**Conditional Use Permit - CU-25-007**

# Villa Vista Townhomes

## Development Agreement (CCOZ)

## CONCEPT SITE PLAN

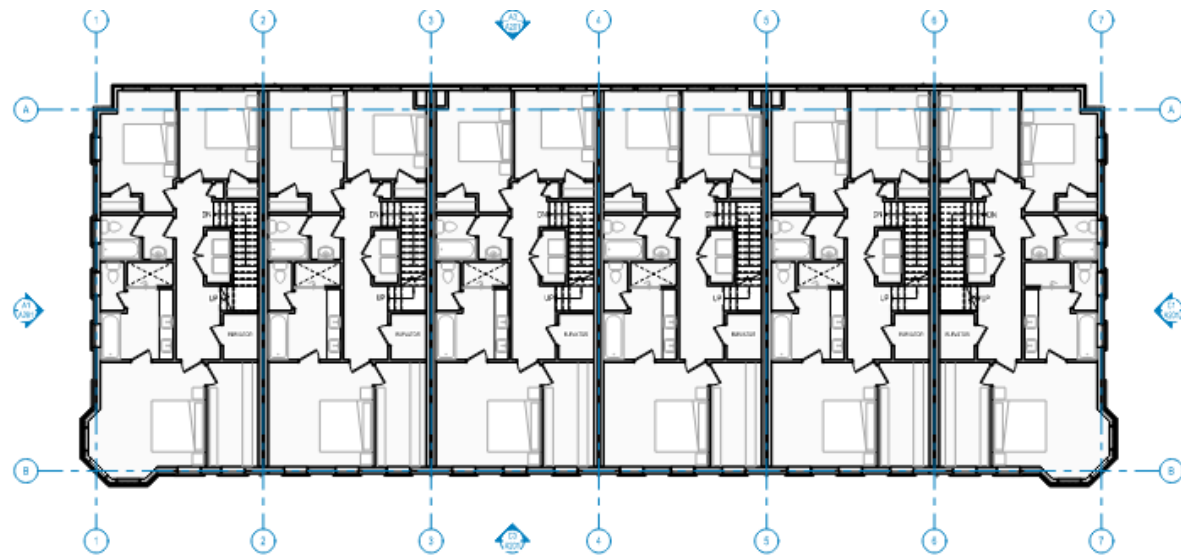
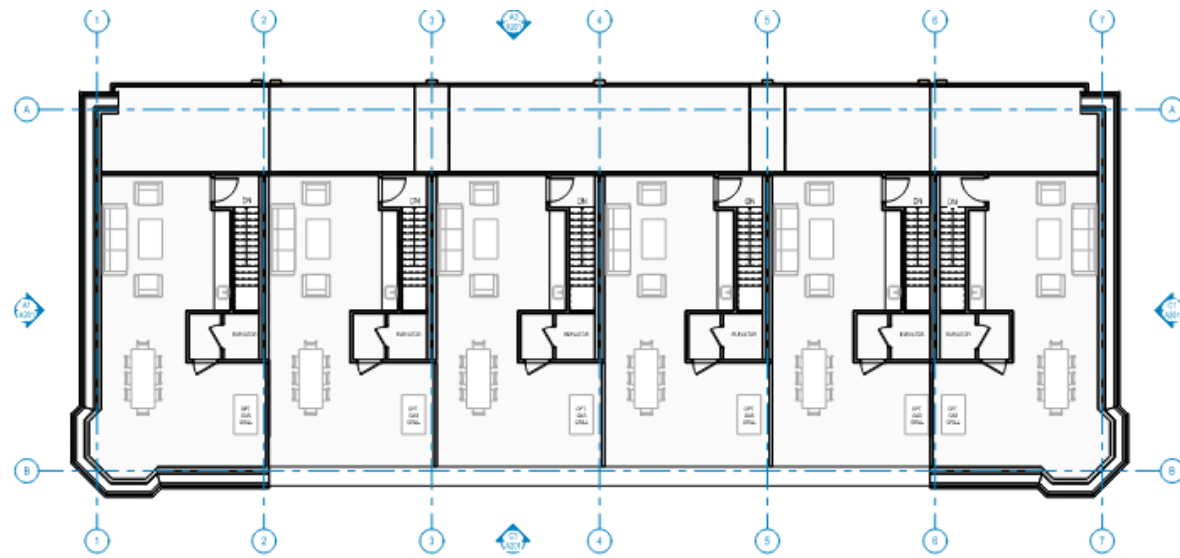
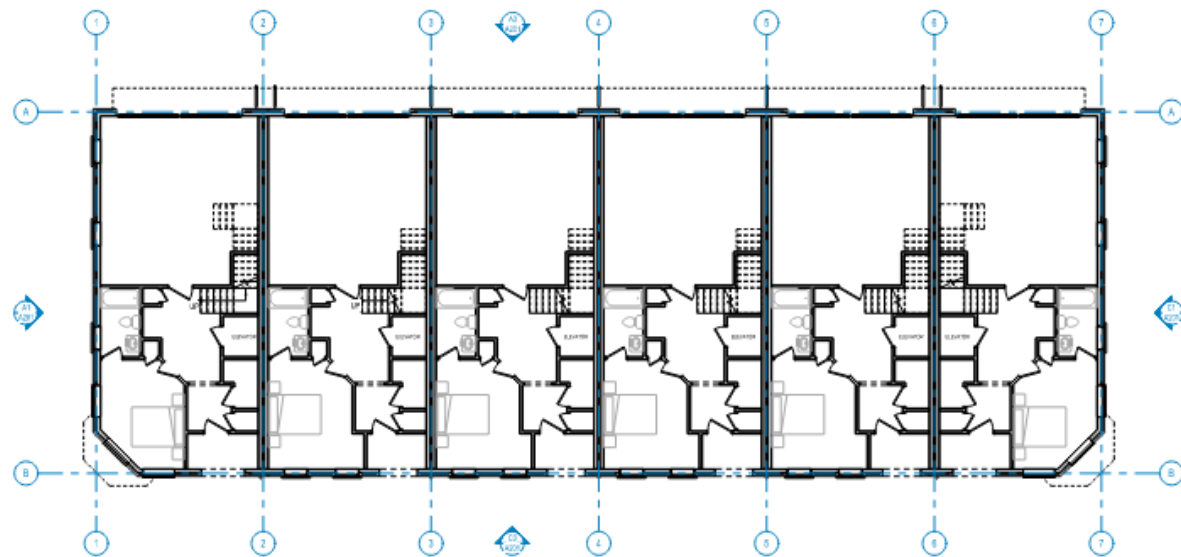
- As per MKZ 18.47.070, the developer would be required to provide 20-foot step back (Street-facing Façade) between the top of the first story and the top of the third and upper stories. The applicant does not comply with this requirement on the Villa Vista Ave façade of building 3.

of the third story and upper stories. The applicant does not comply with this requirement on the Villa Vista Ave façade of building 3.

- As per MKZ 18.47.070, a 10-foot setback along a façade facing a side property line is required between the top of the first story and the top of the third story and upper stories. The applicant does not comply with this requirement.

- For street-facing building facades, exterior building materials used shall consist of a minimum of 75 percent brick or stone excluding windows. The applicant currently does not meet this requirement, as the applicant is proposing 61% brick along the Villa vista street facing façade and 55% brick along Richmond Street-facing façade.

- Windows shall constitute at least 50 percent of first story street-facing facades, and windows shall be at least 50 percent transparent. The current proposal does not meet the glassing requirements set forth in MKZ 18.44.080, as this requirement may apply to first-floor commercial buildings, rather than rowhouse townhomes. The applicant intends to utilize the Development Agreement to deviate from this requirement; However, the applicant is proposing the following:

When a residential use occupies the first story, windows shall constitute at least **33 %** of first story street-facing facades. Windows shall constitute at least **25%** of all upper-story facades. Currently, the applicant has provided **18% and 20%**

Street cross-sections

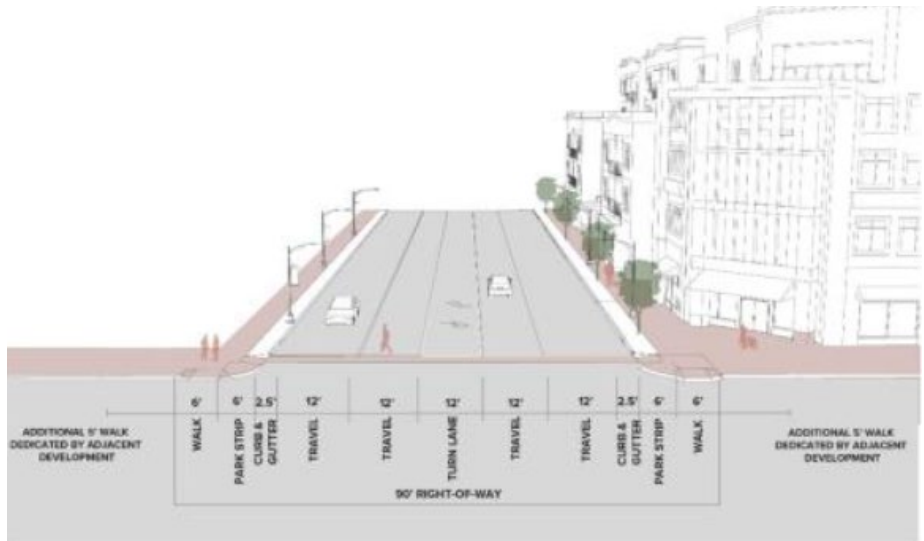
Left turn from Villa Vista into Richmond was suggested by residents on Richmond St. This turning lane is addressed on the street cross-section for Richmond Street.

# Parking

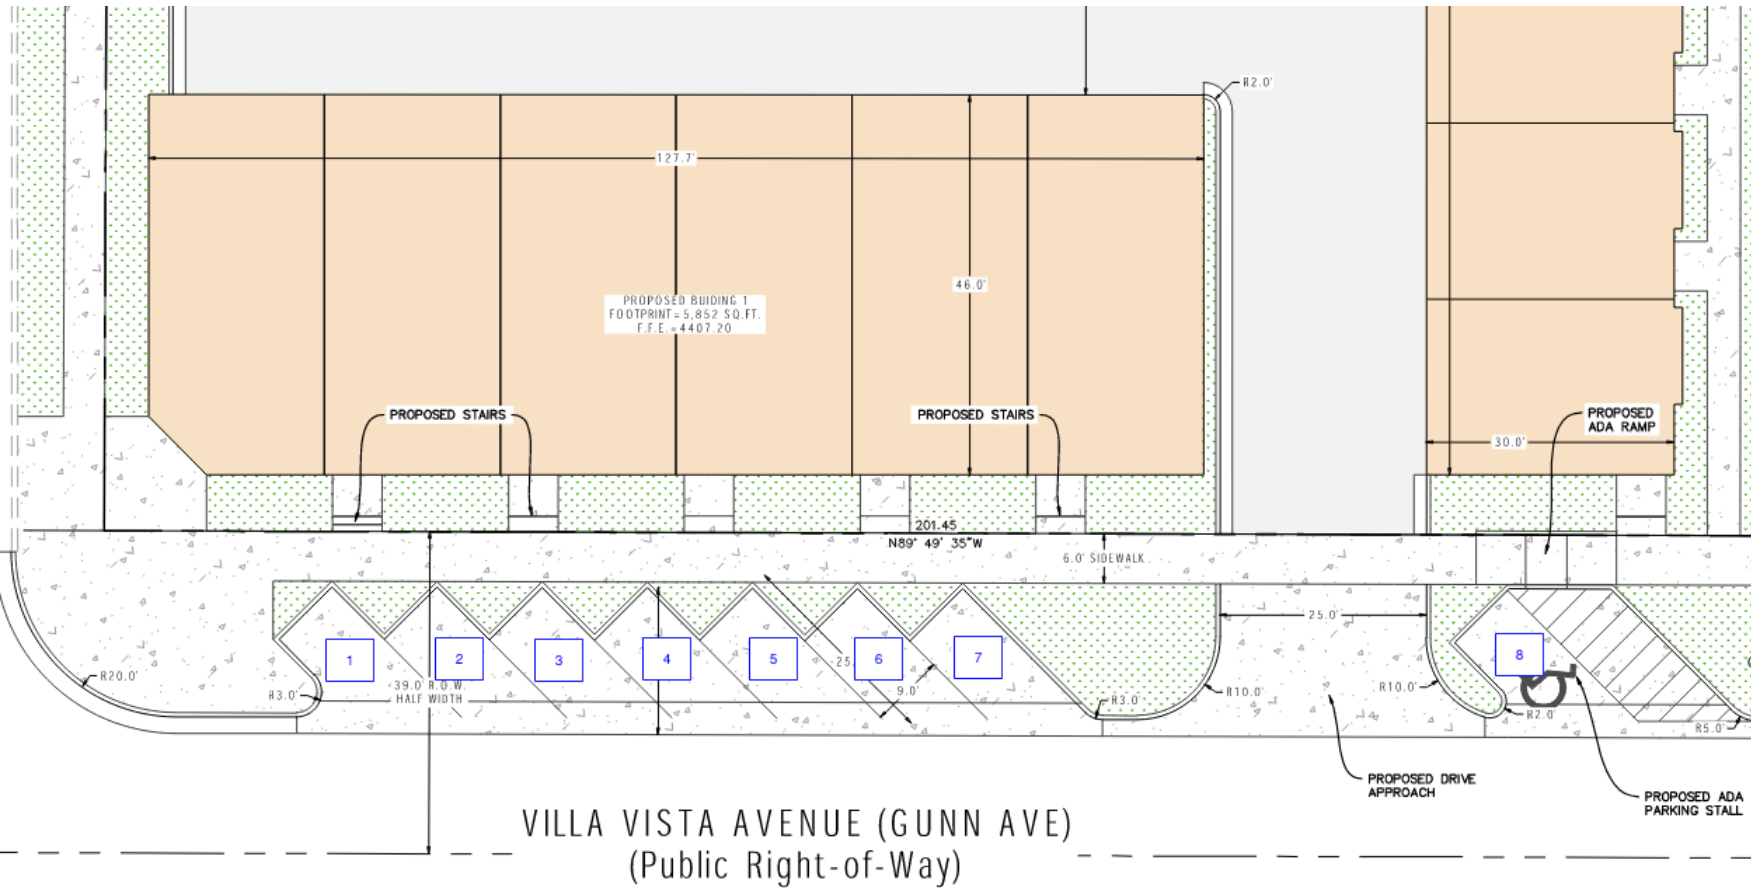
Therefore, six (6) out of the eight (8) on-street parking stall may be used as guest parking. However, the city will start enforcing 2-hour parking throughout the entirety of Villa Vista, including this project.

Required guest parking: 18 (units) x 0.25 (spaces per unit for visitor parking)” = 4.5 stalls, rounded to 5.

## Irrigation Ditch

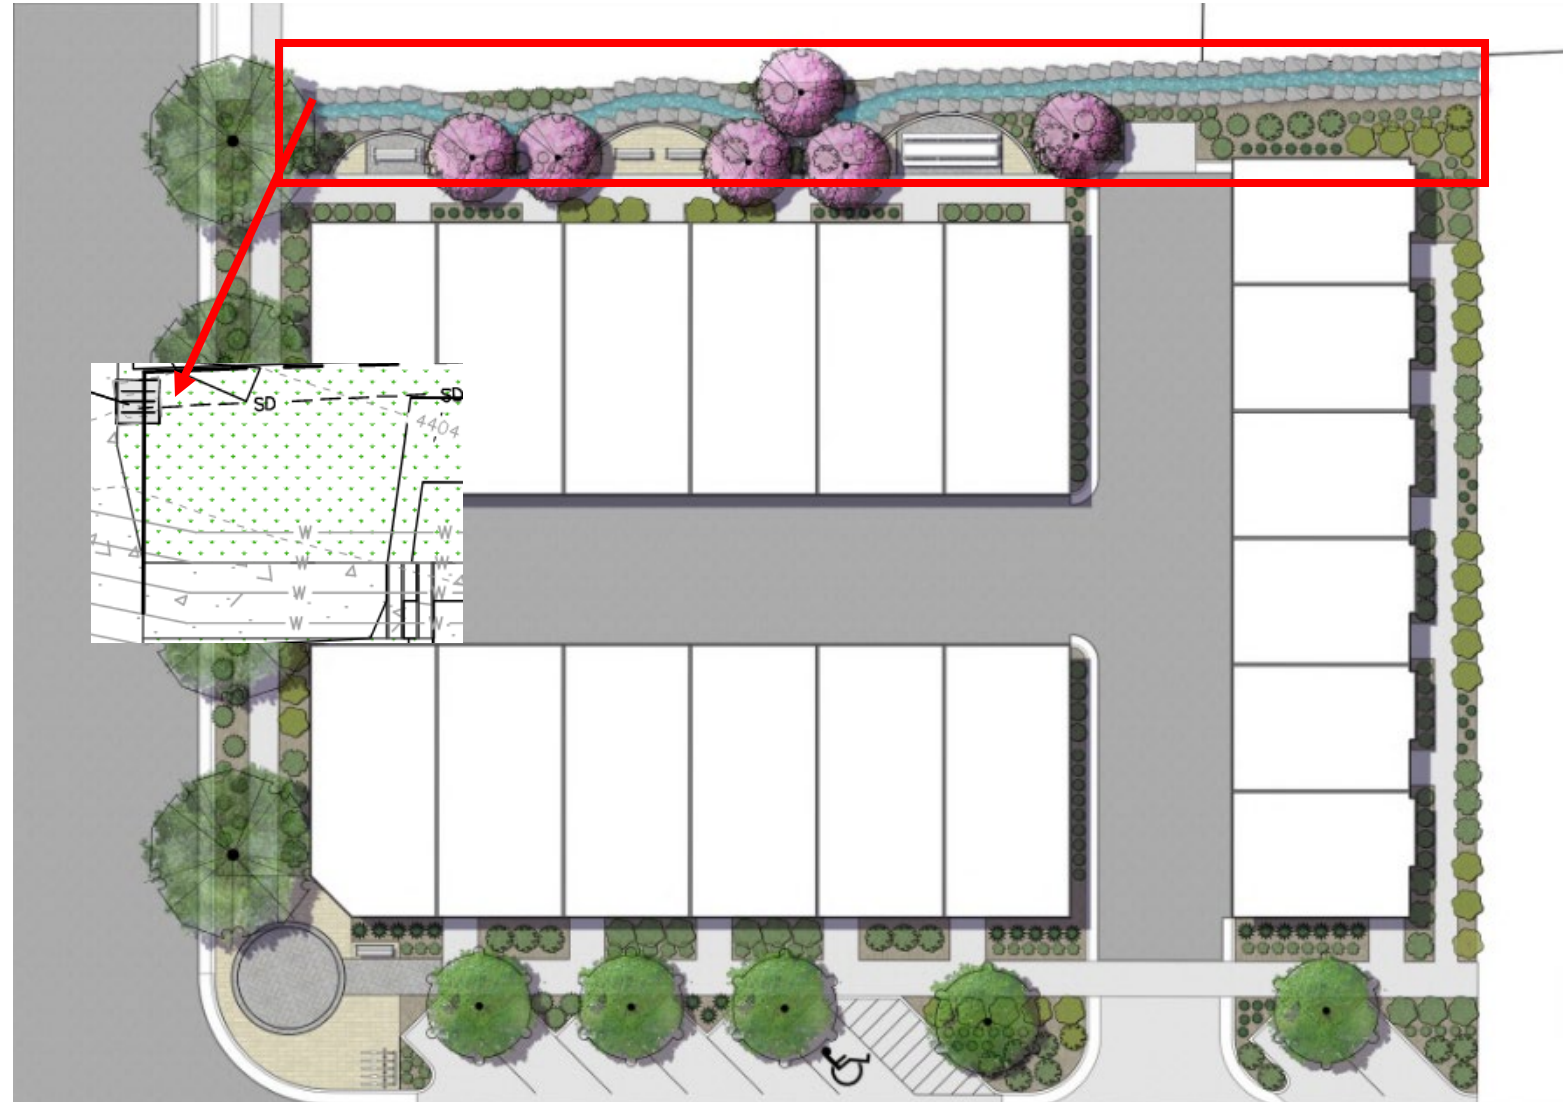
Ditch running across northern property line.

Historically, a potential reason for flooding neighborhood near Richmond St.

Neighbors have asked for new clean out boxes and/or any other remedy to mitigate flooding on Richmond St.

Any mitigation will need to be identified on Development Agreement.
